## **Change List (California MUTCD)**

(Compares California Supplement issued on May 20, 2004  
to California MUTCD released on September 26, 2006)

## CHANGES FOR 2014 CA MUTCD REVISION 2

**Figure 3B-17 (CA). Examples of Crosswalk Enhancements at Uncontrolled Multilane Approaches**

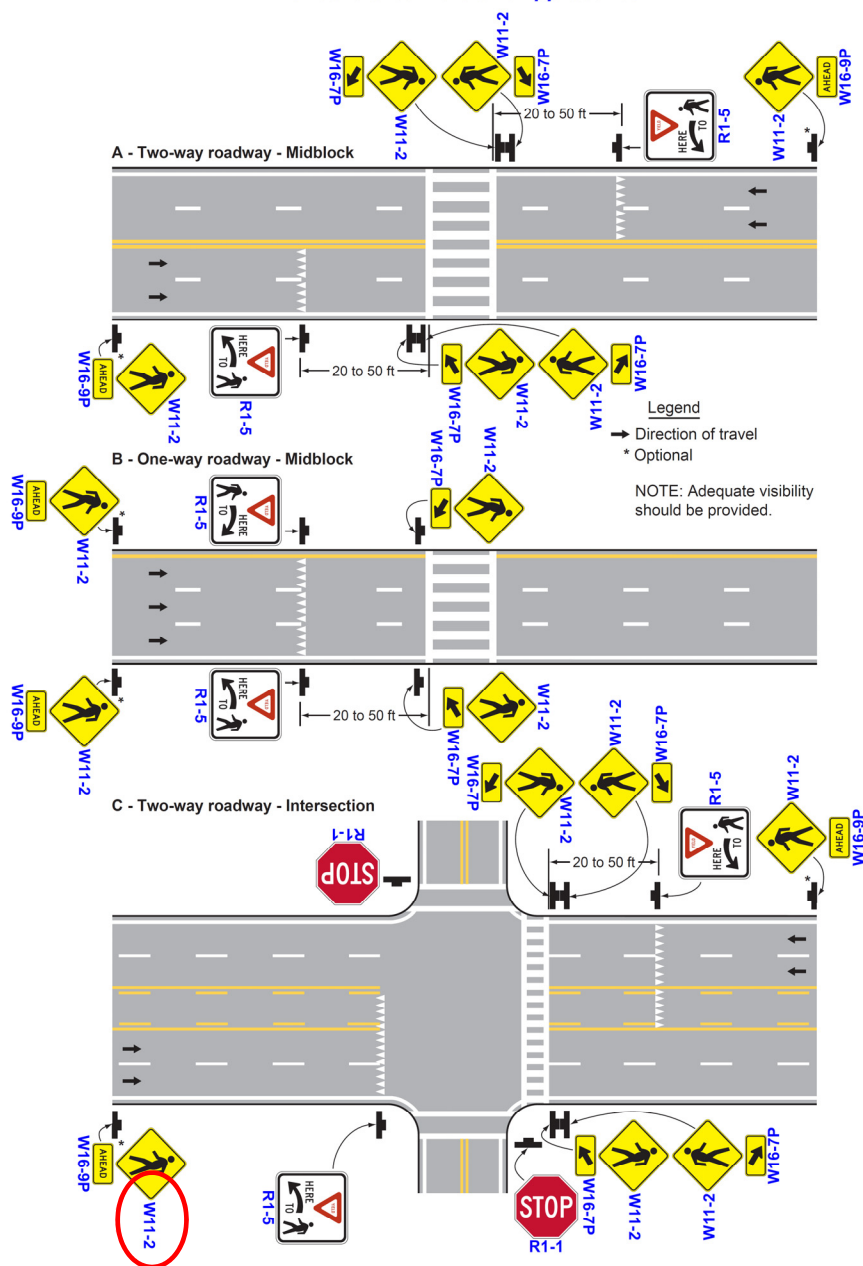
- Chapter 3B, Figure 3B-17(CA)- Changed incorrectly labelled R1-1 to W11-2

**Figure 3B-107 (CA). Examples of Signing and Marking Turnouts**

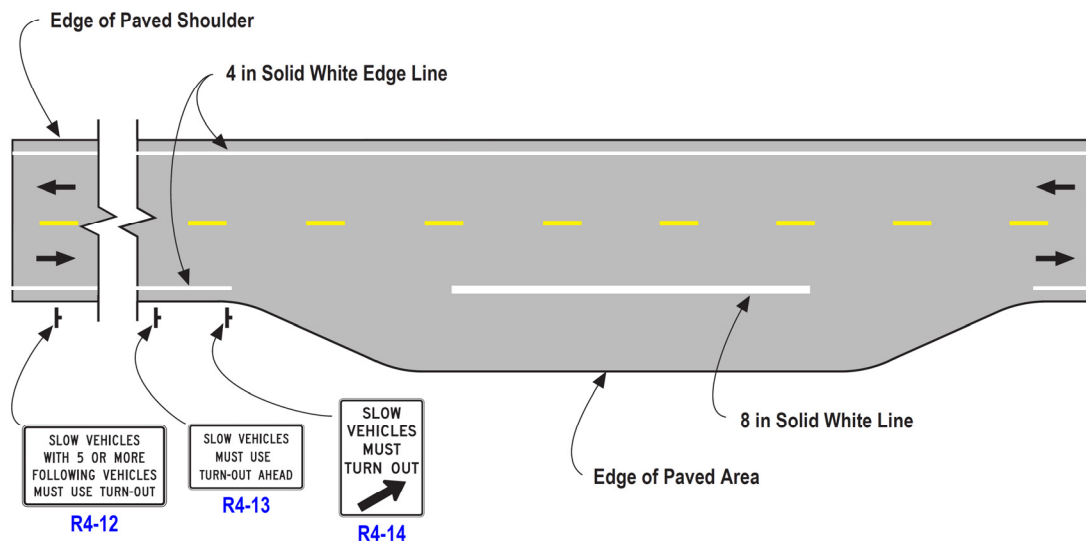
- Chapter 3B, Figure 3B-107(CA)-Switched R4-13 and R4-12 to be consistent with Section 2B.35 Paragraph 04

**Figure 4D-104 (CA). Typical Signal Layout (Three Phase Operation)**

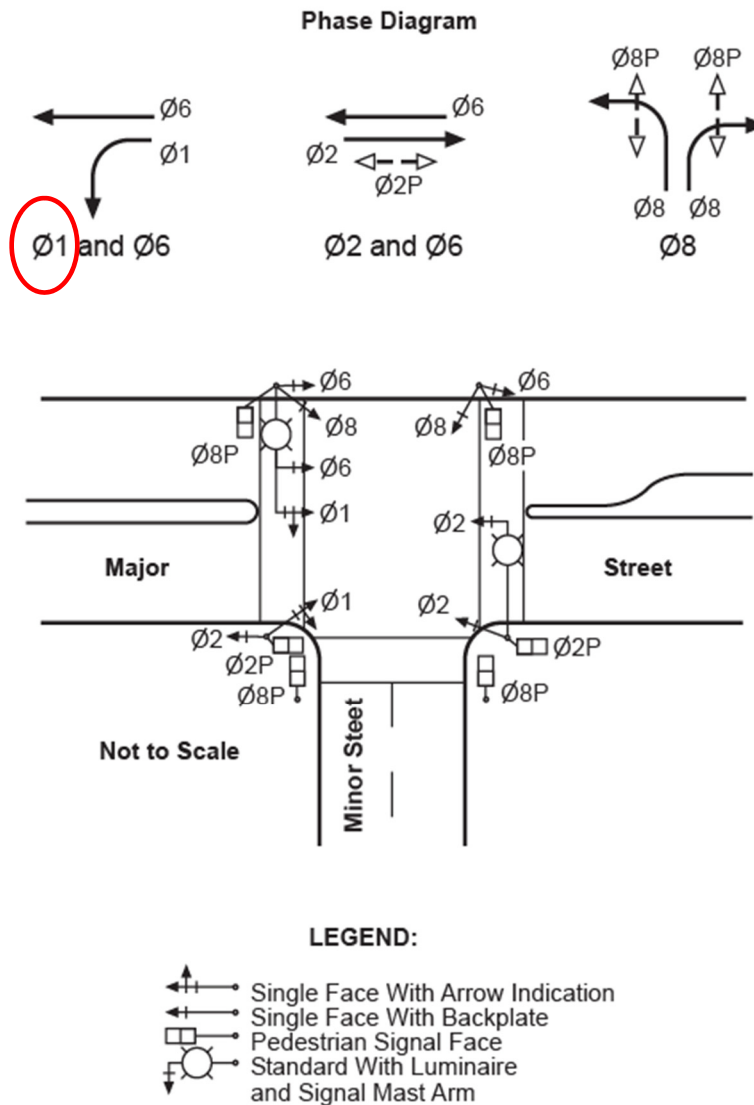
- Chapter 4D, Figure 4D-104 (CA); the first phasing sequence (top left) of the diagram should have been titled phases 1 and 6 and not 2 and 6. Phase 2 was changed to phase 1

Figure 5B-1. Regulatory Signs on Low-Volume Roads

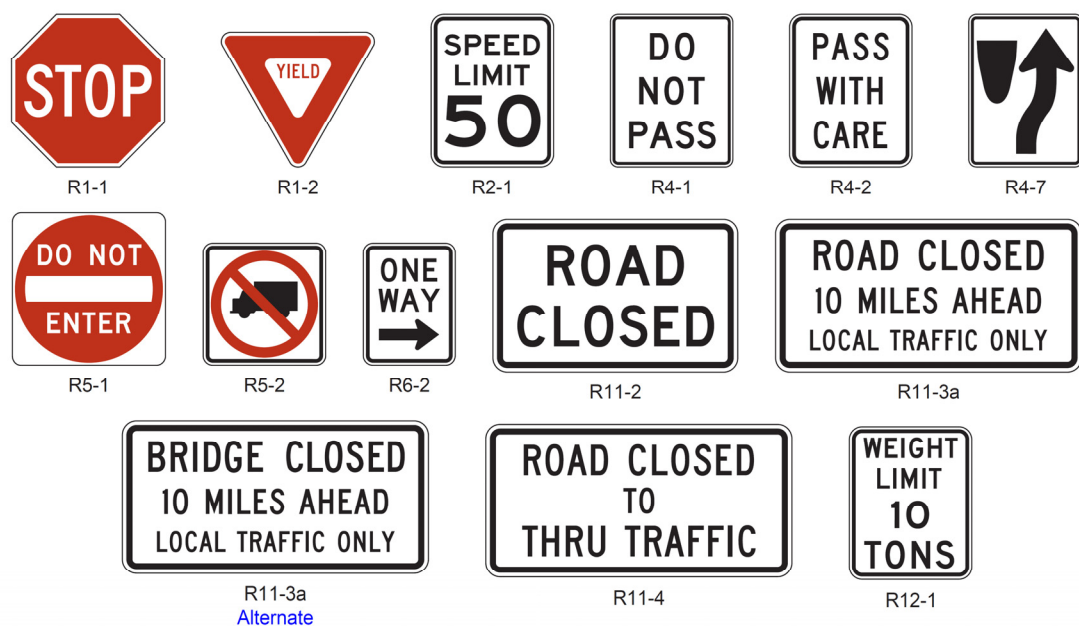
- Chapter 5B, Figure 5B-1, Revised R11-3a to indicate “Bridge Closed” vs. “Bridge Out”. A similar change was made in Figure 2B-29, for the 2014 CA MUTCD Revision 1.

**Figure 6F-3. Regulatory Signs and Plaques in Temporary Traffic Control Zones**  
(Sheet 2 of 2)

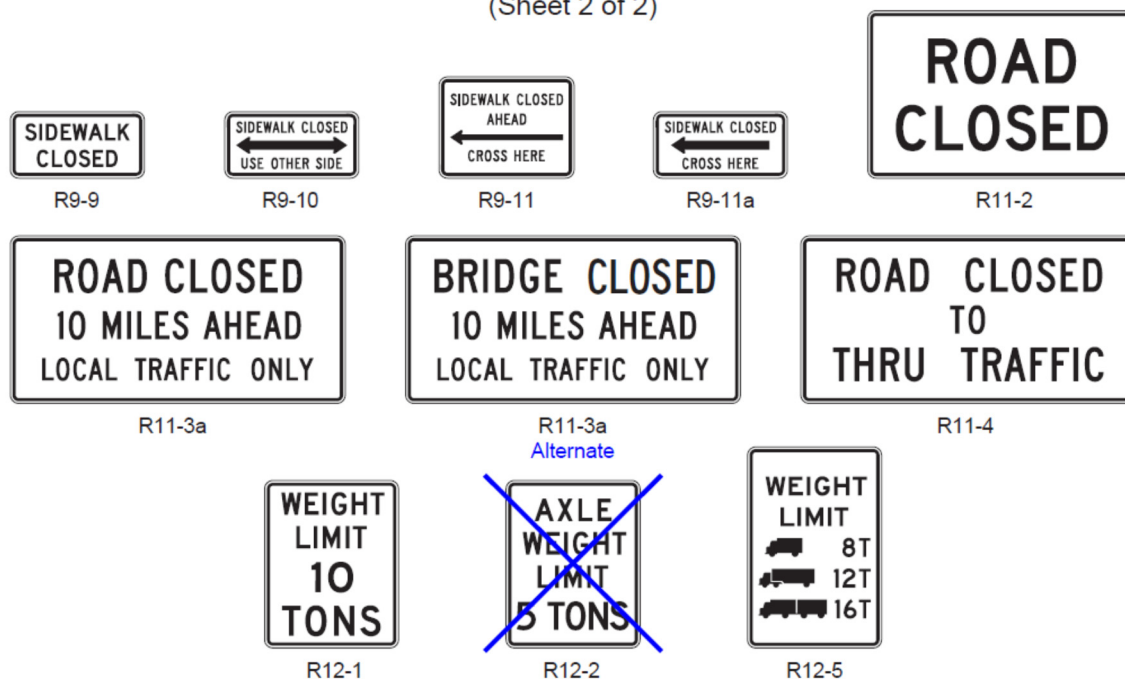
- Chapter 6F, Figure 6F-3 Revised R11-3a to indicate “Bridge Closed” vs. “Bridge Out” to match text in Section 6F.08 and 6F.09. A similar change was made in Figure 2B-29, for the 2014 CA MUTCD Revision 1.

**Figure 2C-11 (CA). Non-Vehicular Warning Signs**

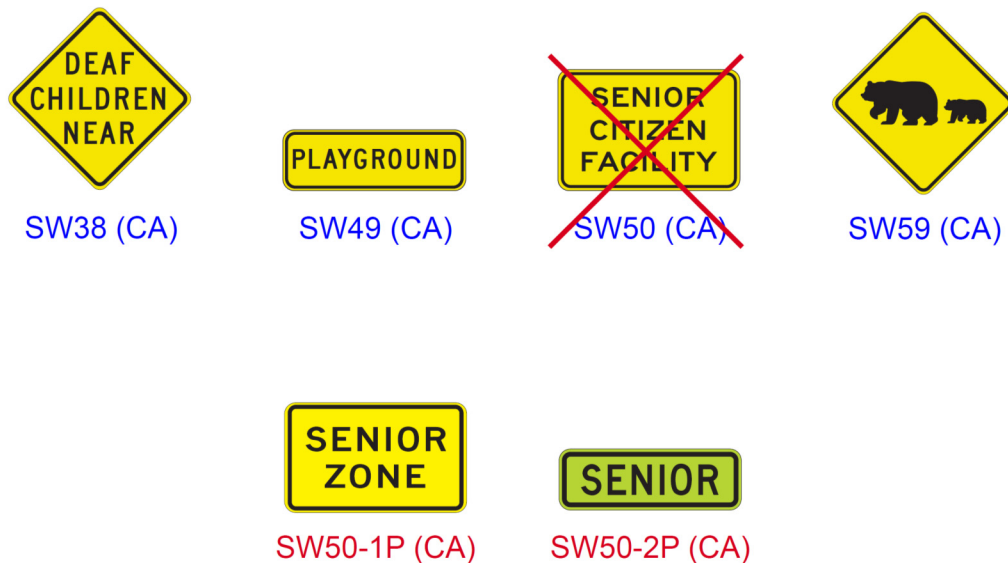
09g The ~~SW50(CA)~~ sign SENIOR ZONE (SW50-1P(CA)) plaque or SENIOR (SW50-2P(CA)) plaque (see Figure 2C-11(CA)) may be used in combination, above the Speed Limit (R2-1 (25,20 or 15)) sign on any street or road, other than a State highway, with a speed limit greater than 25 mph that is adjacent to a senior citizen facility. Refer to CVC 22352 and 22358.4.
